**SUBJECT:** Limerick Generating Station, Units 1 and 2  
Response to Request for Additional Information Regarding Review of  
Individual Plant Examination of External Events

Response to Request for Additional Information  
Limerick Generating Station, Units 1 and 2  
Individual Plant Examination of External Events (IPEEE)

Figure S3.1

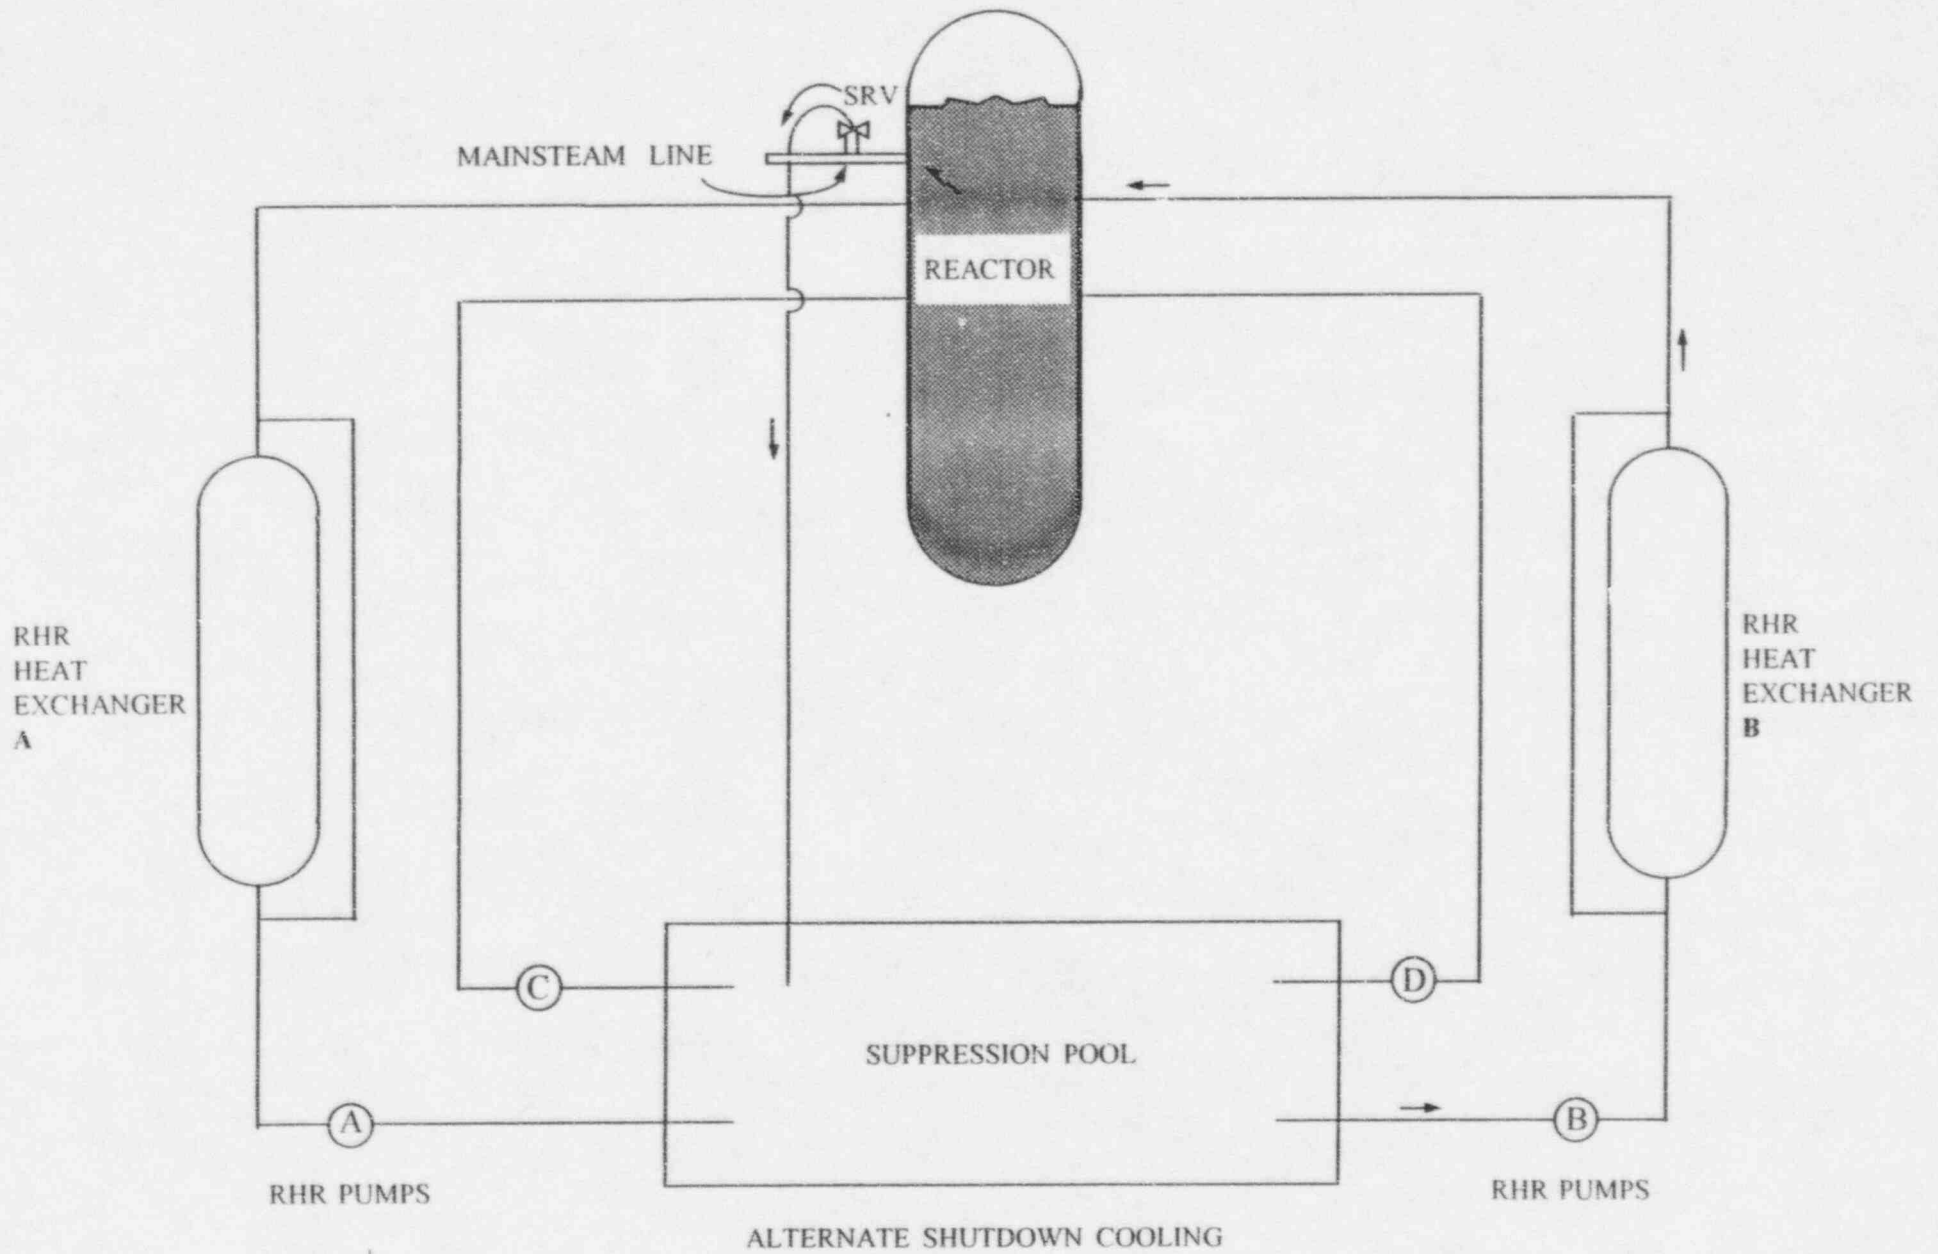
3. The alternate shutdown success path uses Low Pressure Coolant Injection/Residual Heat Removal (LPCI/RHR) "C" and "D" loops for inventory control and the "B" loop for suppression pool cooling. Identify and explain how the LPCI/RHR system is used in the alternate shutdown path (indicating what trains of the system must operate in order for the alternate shutdown path to succeed), and explain how non-seismic failures were accounted for in this regard.

3. The Limerick RHR system for each unit has four trains. Each train has its own injection path (four injection points total per unit). In the alternate success path, the "C" and "D" RHR trains are used for dedicated LPCI mode, taking suction from the suppression pool and injecting into the reactor vessel. The "B" RHR train takes suction from the suppression pool and passes it through the "B" RHR heat exchanger (suppression pool cooling function) to the reactor. The water returns to the suppression pool via an open SRV (reactor heat removal function). The complete pathway from the suppression pool through the RHR heat exchanger to the reactor vessel and through the SRV to the suppression pool is referred to as alternate shutdown cooling and is shown in Figure S3.1 (attached).

Non-seismic failures were accounted for in the use of both "C" and "D" trains of RHR for level control. If necessary, the "D" RHR pump may be aligned in non-LPCI modes using the B RHR Heat Exchanger. Failure of an SRV is not significant because of the number (5 ADS SRVs and an additional 9 non-ADS SRVs) available.

Figure S4.1

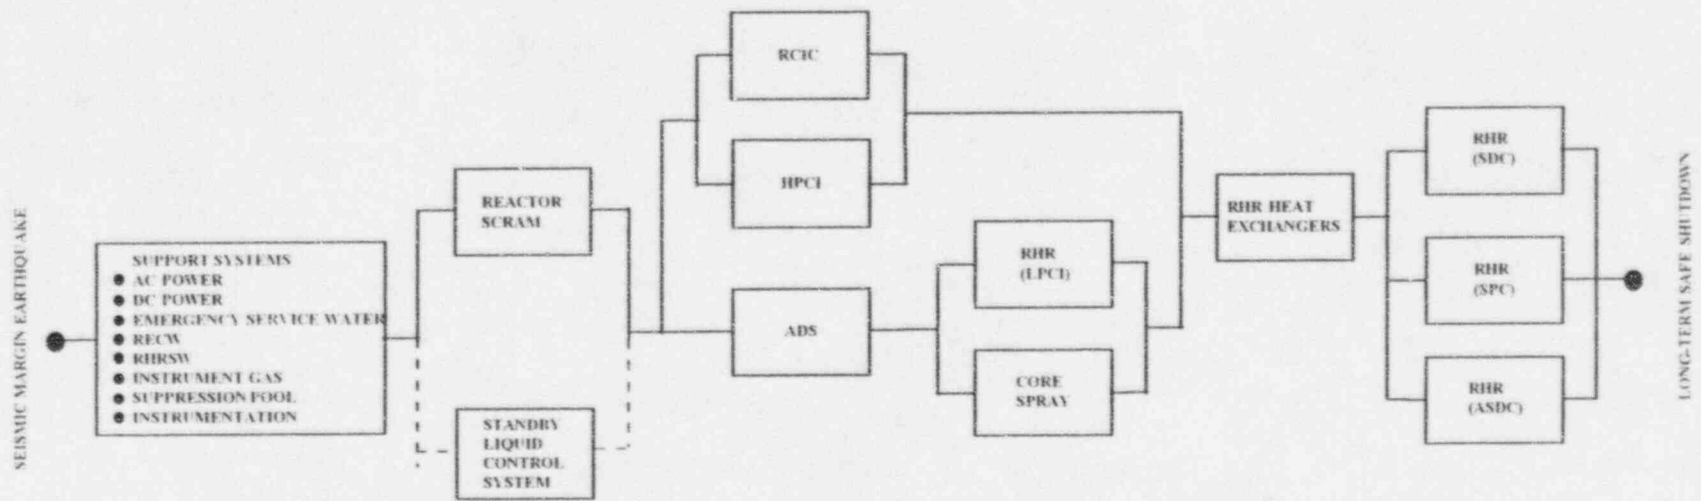
4. Provide a copy of the "Success Path Logic Diagram" (SPLD) which is referred to in Section 3.1.2.5.4.1 of the IPEEE submittal report.

4. Figure S4.1 (attached) is the SPLD for Limerick.

**FIRE AREA EVENT TREE FOR  
 LIMERICK GENERATING STATION**  
 TRANSFER FROM FIRES03  
 CONDENSATE FOR INJECTION

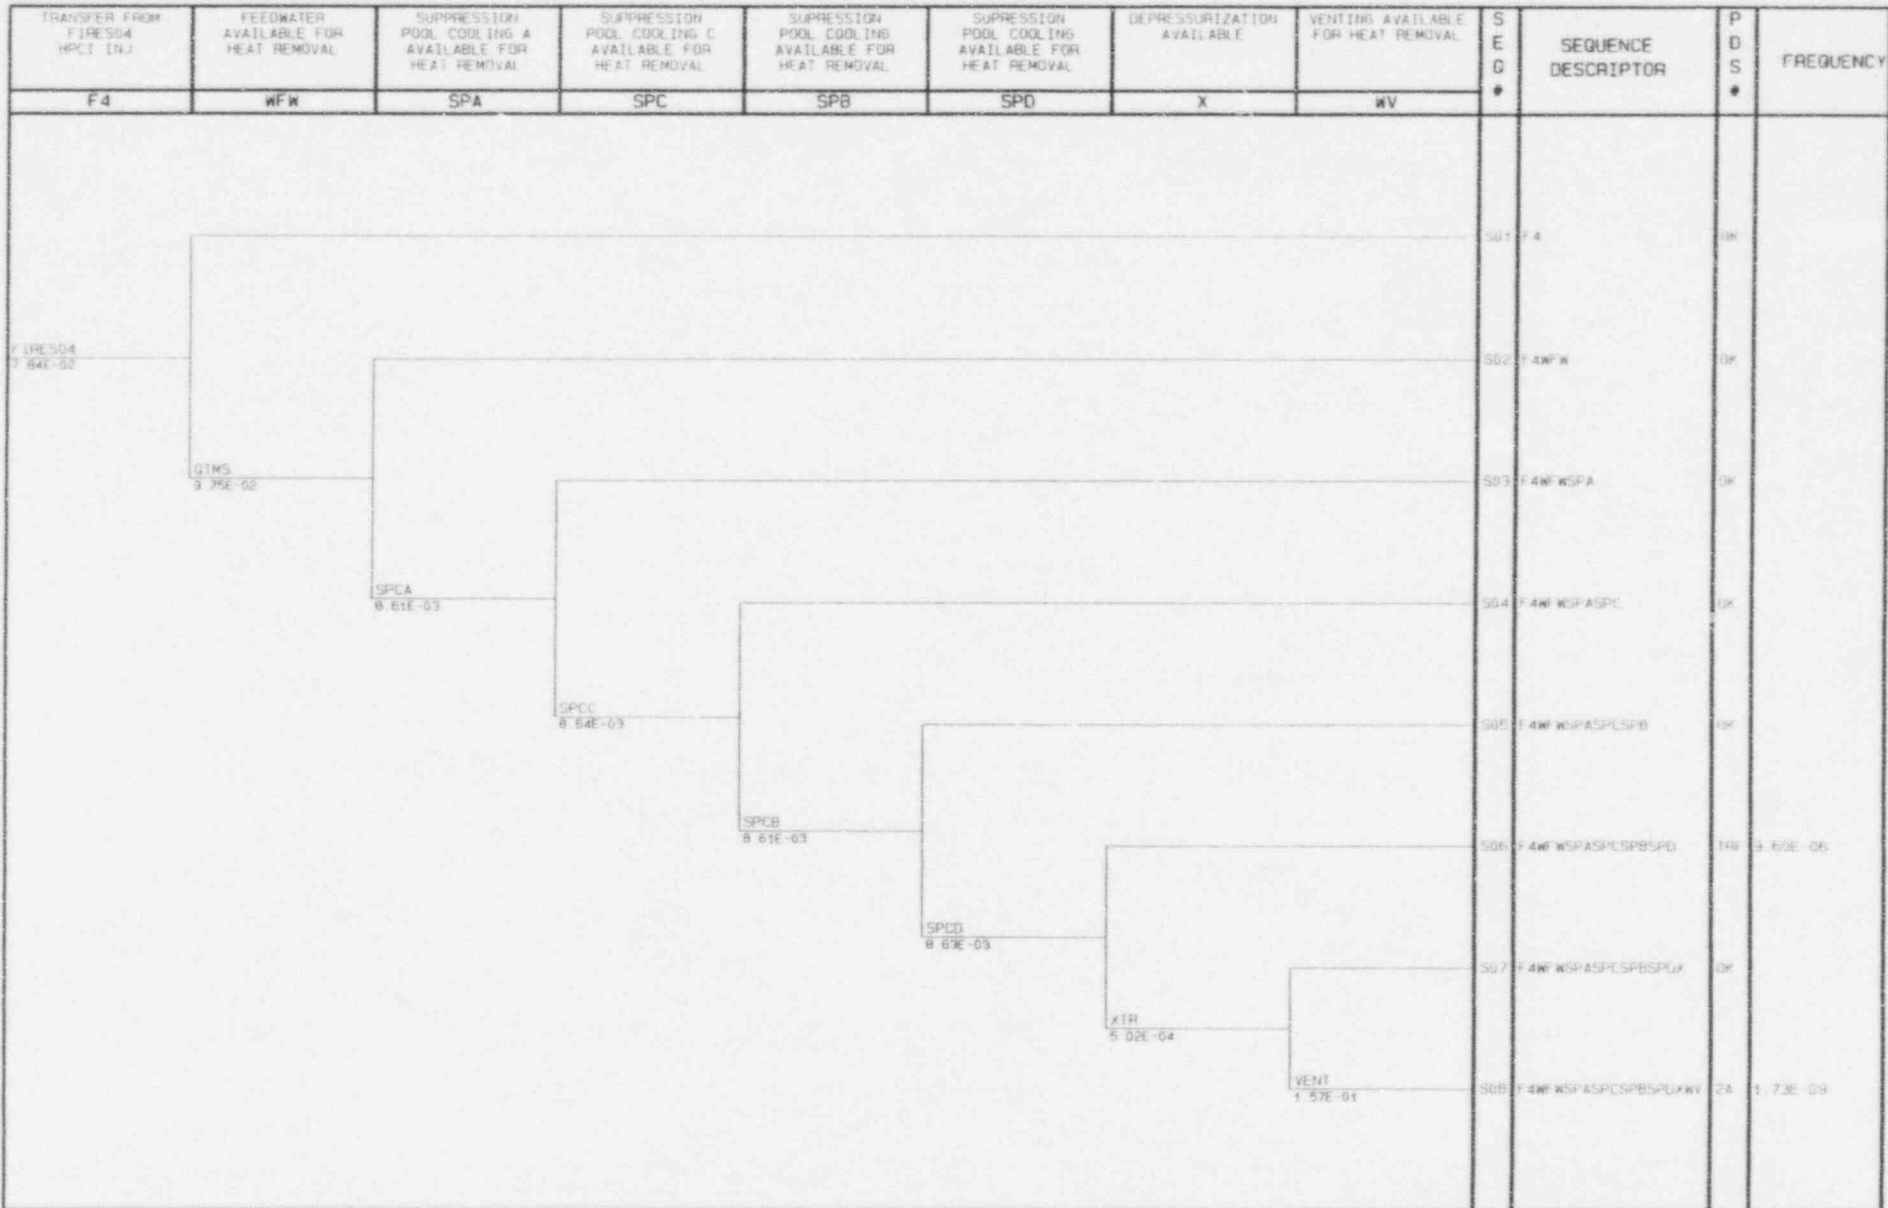
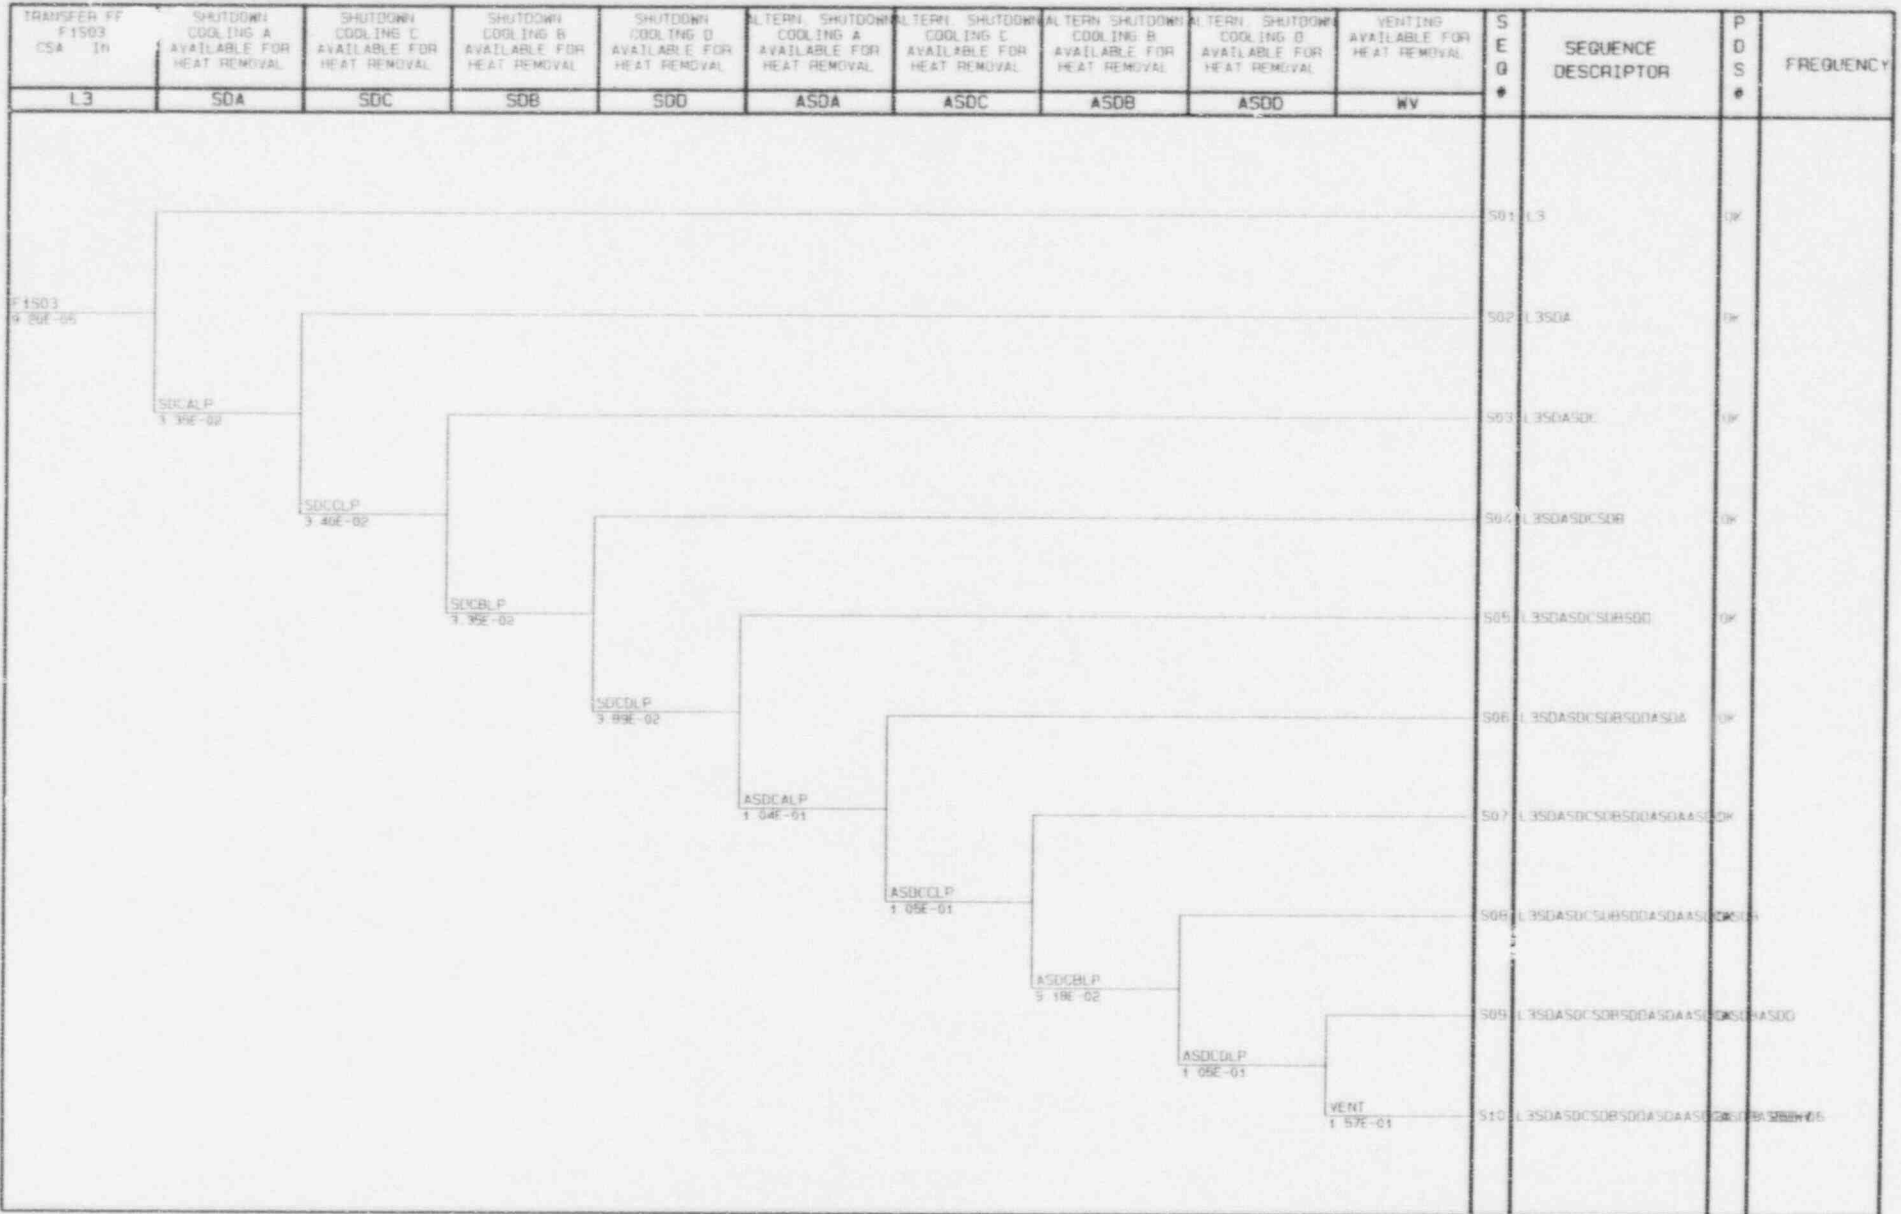
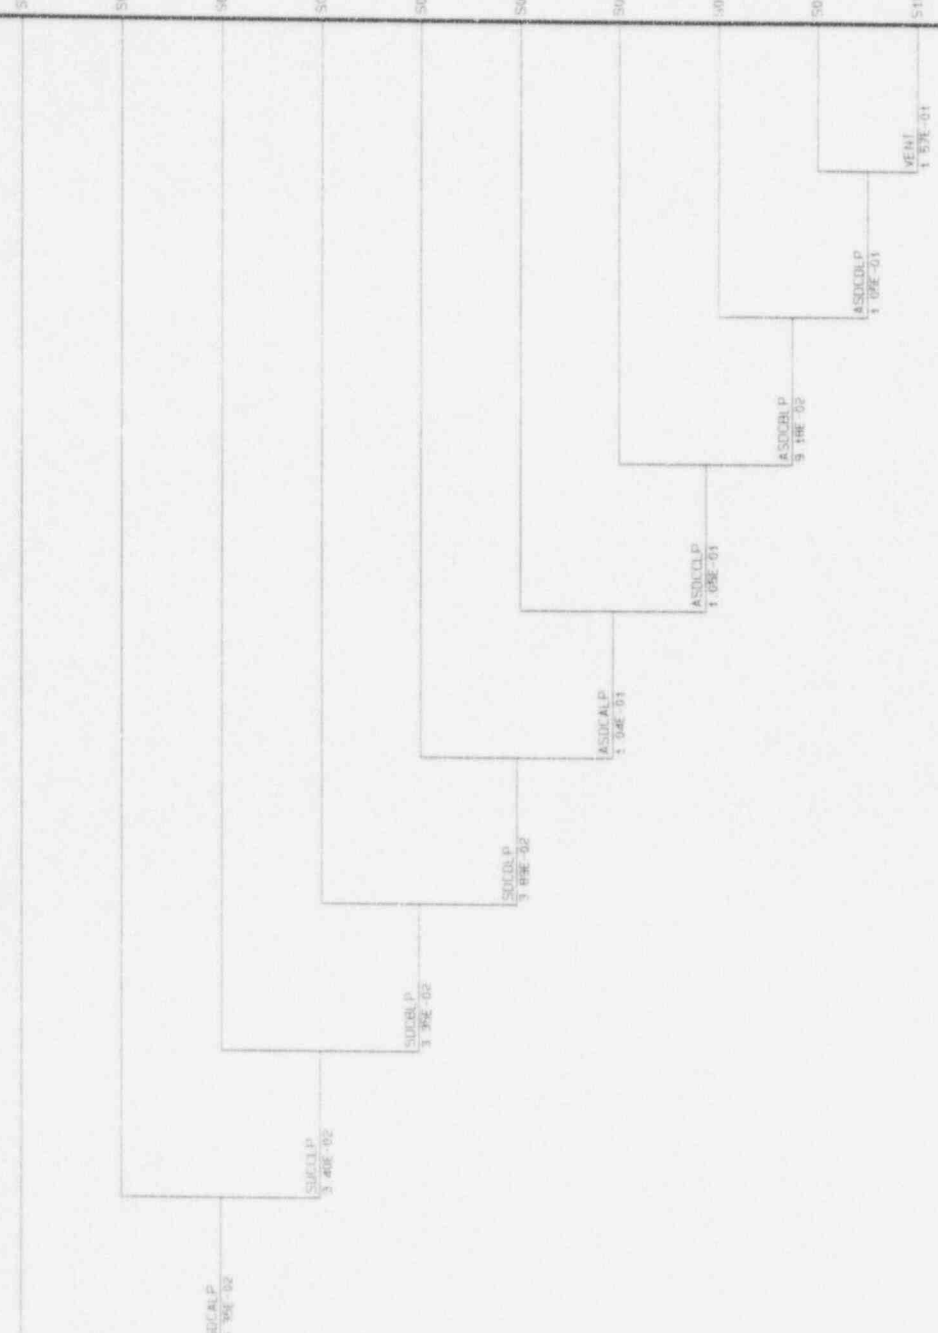
5. The IPEEE submittal notes that a generic event tree was developed to represent the potential shutdown systems available and was used as a template for individual fire areas. The event trees were then modified to specifically model each unique set of systems categorized as successful and failed for each particular fire compartment. Provide a copy of the event tree (including definitions of all event tree top events), a listing of the conditional probability of all events in the tree, and a discussion of the bases for the quantification values used.

Explain how initiating events other than an automatic or manual reactor trip (e.g., fire-induced loss of offsite power) were considered, including specifically how they were modeled.

5. A copy of the event tree(s) is provided. The event tree top events and the conditional probabilities are represented directly on the tree(s). The bases for the quantification values used are those typically described in the LGS IPE submittal. The one exception to this is the quantification of the vent path failure. Only one vent path was considered in the fire analysis because of the number of cables that would need to be identified and tracked from a fire perspective if the multiple vent paths were modeled similar to the IPE.
